F/25/99361 Vehicular access off Satchell Lane to ESSO fuel compound

Ecology Response 1.7.25

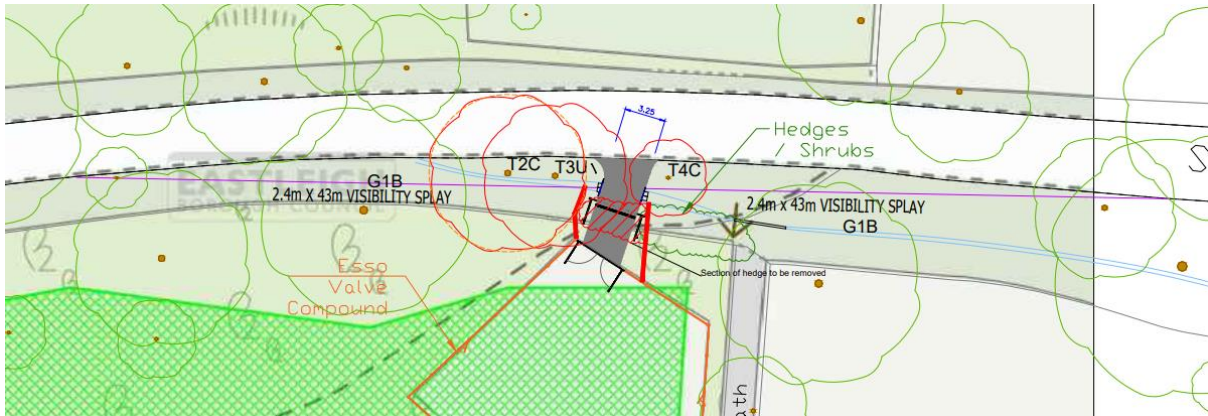
The historic bank on which oak T2 sits, is particularly high at this location. As T2 is within a visibility splay and therefore would need to be removed, the bank also may need to be lowered significantly within the splay(s) therefore also removing its associated flora.

Please note however, even without full details submitted, as the scheme stands it appears the extent of habitat loss is too great and disproportionate to justify the new access point. Modification of the proposals is required to reduce the habitat loss to an acceptable level.
